ADDENDUM NO. 1

DATE: September 14, 2026

PROJECT: HWY 107 Water Line Relocation
Cabot WaterWorks
Cabot, Arkansas

OVERALL SITE PROFILE
SCALE: (H)1" = 300', (V) 1" = 50'

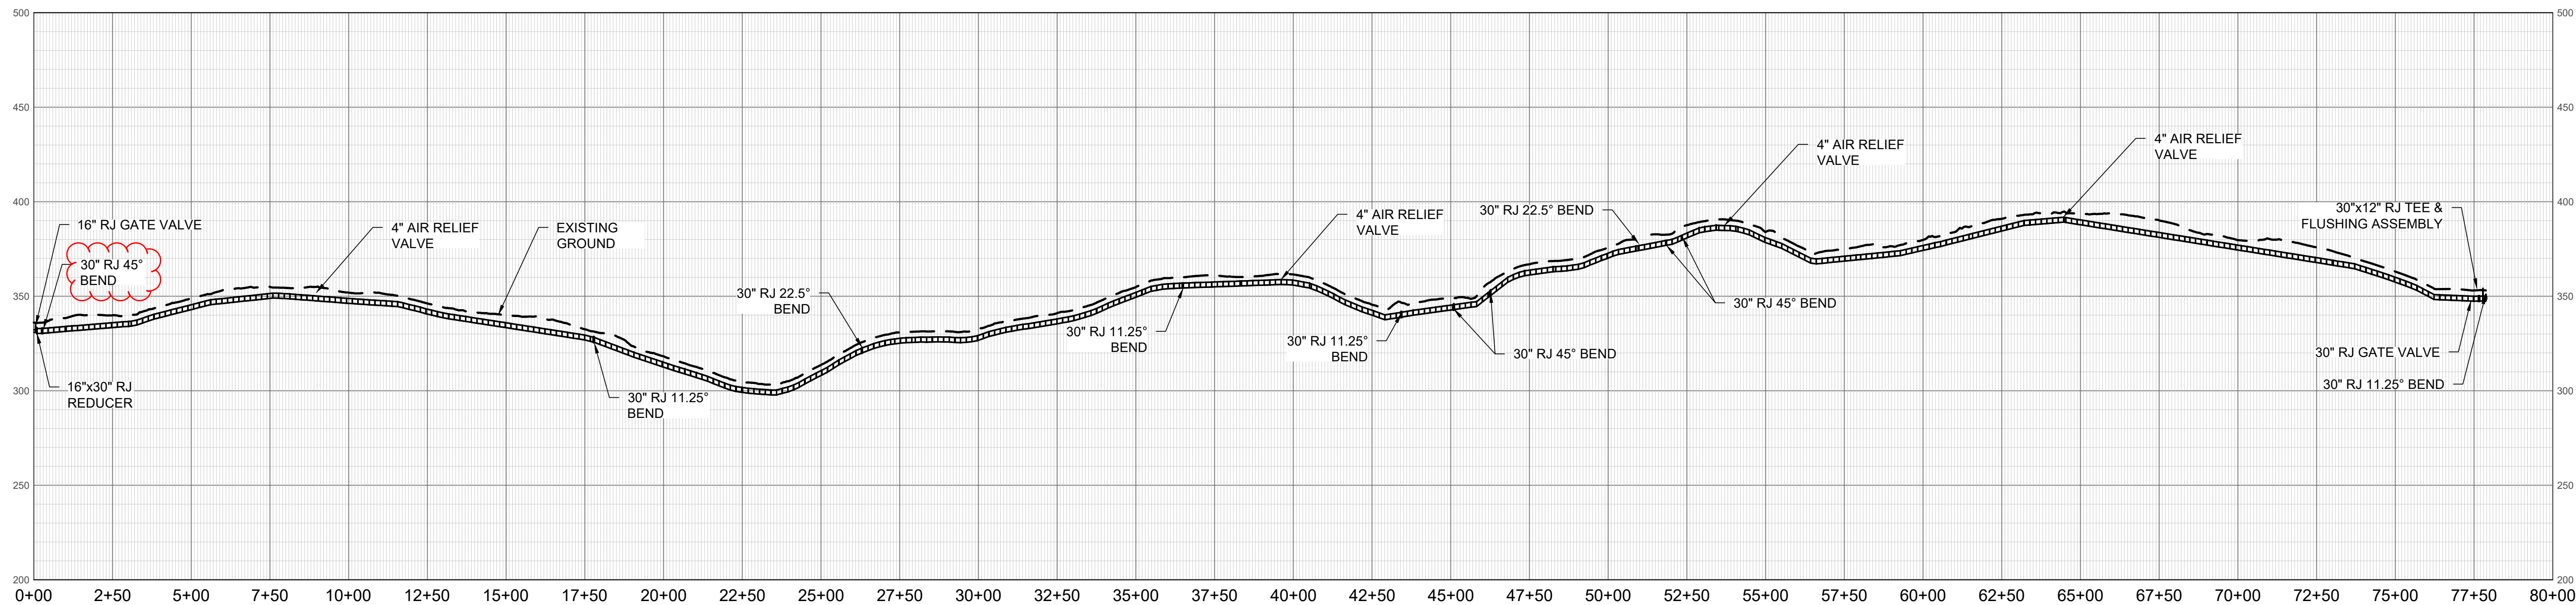
- B. Modification(s) to this drawing as shown in Addendum No. 1 – OVERALL SITE PROFILE, attached hereto.
 - a. See revised notation "30-Inch RJ 45° Bend" at STA 0+28

PAVED OR GRAVEL DRIVE REPAIR (B)
N.T.S. 7, 12

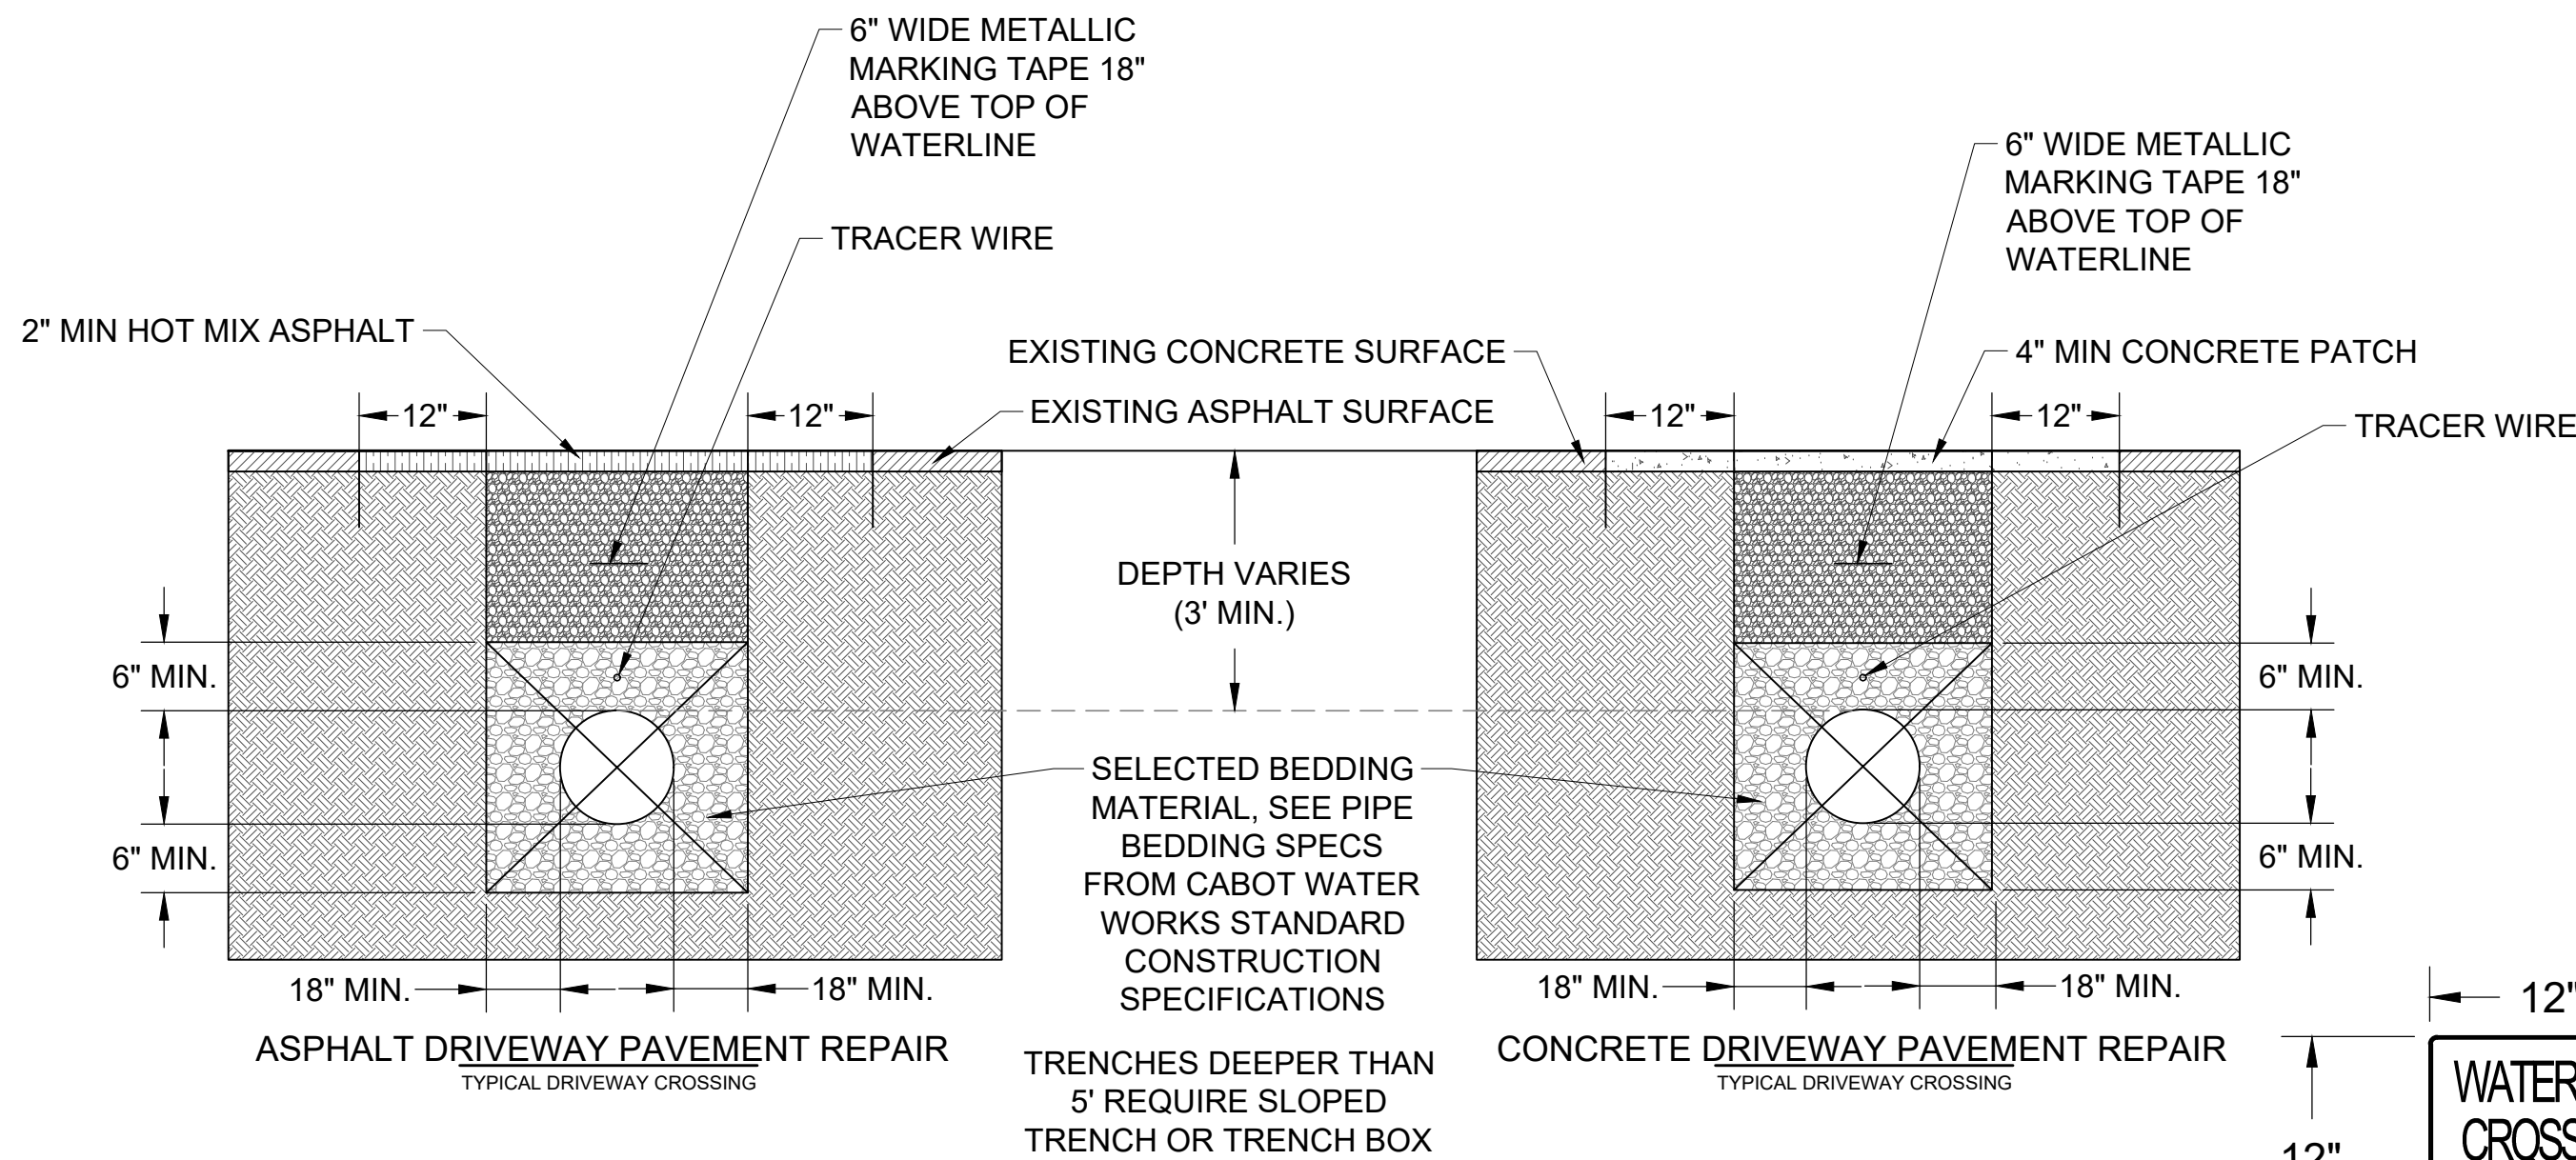
- A. Modification(s) to this drawing as shown in Addendum No. 1 – CIVIL SITE DETAILS - II, attached hereto.
 - a. SEE DETAIL B. PAVED OR GRAVEL DRIVE REPAIR

- NOTES:
1. THIS DETAIL IS FOR REPAIR OF EXISTING DRIVEWAYS ONLY.
 2. PROVIDE SMOOTH TRANSITION ON FINAL PAVED SURFACES
 3. MATCH EXISTING DRIVEWAY MATERIAL TYPE.
 4. BACKFILL TRENCHES WITH CLASS 7 AGGREGATE BASE COURSE.
